CITY OF HOBART

## **City Infrastructure Committee Meeting**

**11 Sandy Bay Road Walking and Cycling Project - Request to Modify Design to Remove Pedestrian Crossing**  
**File Ref: F17/34564; R0820/26**

**REPORT TITLE: SANDY BAY ROAD WALKING AND CYCLING PROJECT - REQUEST TO MODIFY DESIGN TO REMOVE PEDESTRIAN CROSSING**

**Figure 1 – 795 Sandy Bay Road, approved plan**

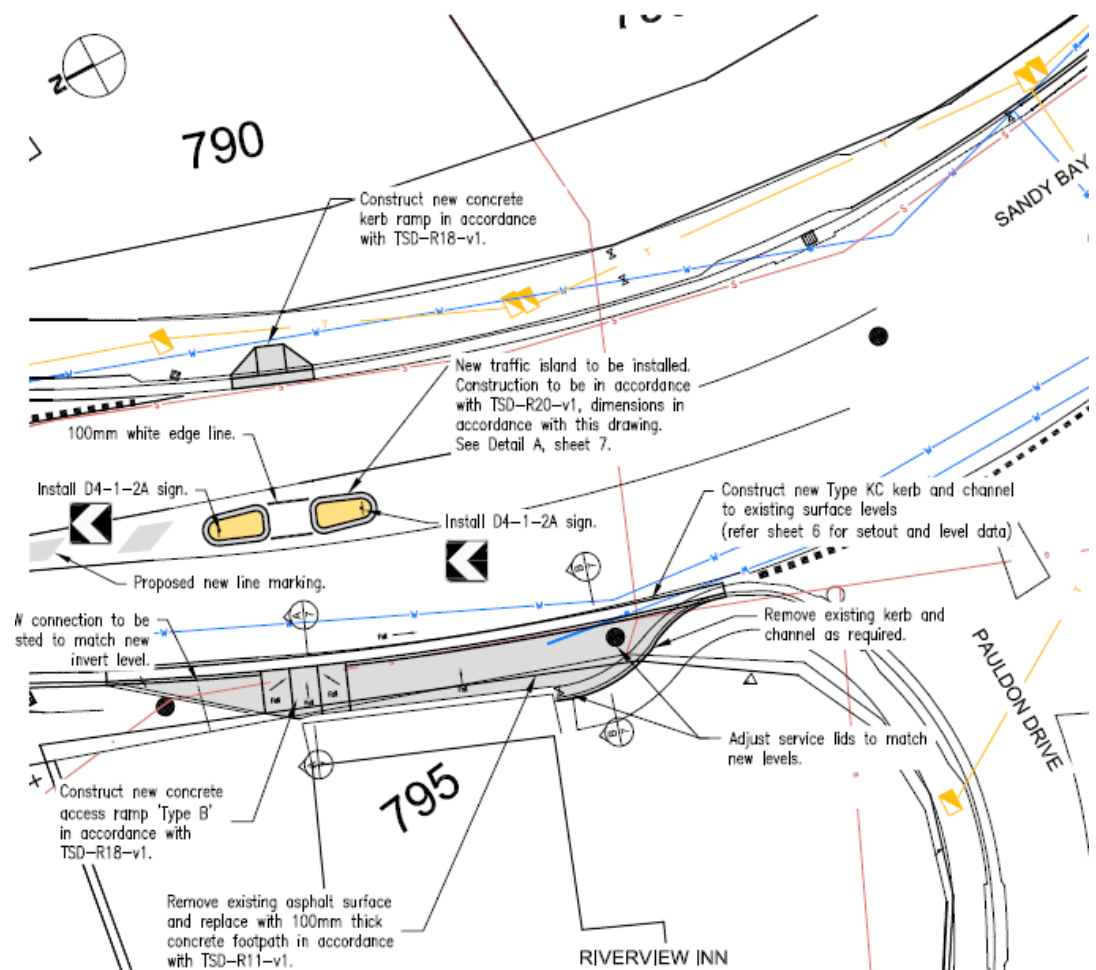
- 4.7. The proposed footpath, pedestrian refuge and pram ramps adjacent to 795 Sandy Bay Road are shown in Figure 1 below and require the removal of an indented parking area that can hold up to three cars. The proposed pedestrian facilities have been provided to allow for residents of Sandy Bay Road, Pauldon Drive and Mitah Crescent to safely cross the road and are in close proximity to an existing bus stop pair on Sandy Bay Road.

1. In its consideration of the planning application for the Inn's extensions, Council planning officers were concerned to ensure provision for adequate vehicular parking for patrons was NOT disturbed. Indeed the view was that the extensions should not impact on the 3 car Spaces available at the front entrance. The finalised plans for the redevelopment were so determined.

2. The current cycle way plans not only eliminate these essential spaces but they also (and without our knowledge or approval) fall partly within the boundary of our land.

3. The very nature of ribbon development in the immediate area around this part of Sandy Bay Road of itself gives rise to an extremely low pedestrian density such that the deletion from the plan of a crossing adjacent to the Inn would not in any way diminish safety at this location. Convenient may be for a few, but essential, and in the most appropriate location, absolutely not.

We acknowledge there is to be a cycle way and its provision must be accommodated within reason at our frontage. We submit that our trading hours of 4.00pm until late should be able to allow for our essential parking at these times notwithstanding the spaces will include part of the cycle way.

Northern cycle movements occur in the main in times outside these times and it should be possible for Council to provide adequate signage limiting this small but necessary parking area to times within our business hours only.

However I am concerned that there should not be any reduction in pedestrian safety in this process. I notice that the pedestrian island has been removed from Sandy Bay Road near the intersection with Pauldon Drive. This removal was included in the detailed design drawings [http://www.hobartcity.com.au/Projects/Other Council Projects/Sandy Bay Road Walking and Cycling Project](http://www.hobartcity.com.au/Projects/Other_Council_Projects/Sandy_Bay_Road_Walking_and_Cycling_Project) as was the installation of a new pedestrian island closer to Mitah Crescent; however the new pedestrian island has not yet been installed. As a resident of Taroona I am only too aware of the importance of pedestrian islands when attempting to cross this busy, winding main road, especially for school students attempting to reach bus stops. I trust that a new pedestrian island will be installed for the residents of Pauldon Drive and Mitah Crescent soon.

1. ***The design for Stage 3 of the Sandy Bay Road Walking and Cycling Project, as approved by the Council at its meeting of 7 September 2015, not be modified and accordingly, the footpath and pedestrian refuge be constructed near 795 Sandy Bay Road.***

- 4.10. The continuation of the footpath and provision of a pedestrian refuge island is an important aspect of this project. Alternative locations for a pedestrian refuge island were considered but the windy nature of Sandy Bay Road meant that adequate sight distance for pedestrians was not achievable. Adequate sight distance for pedestrians can be achieved at the proposed refuge location.

- 5.1. Pedestrian amenity and safety is a higher priority than the provision of on-street car parking. On that basis, it is proposed to complete the approved works for Stage 3 of the Sandy Bay Walking and Cycling project – including the footpath extension, pedestrian refuge and pram ramps adjacent to 795 Sandy Bay Road.
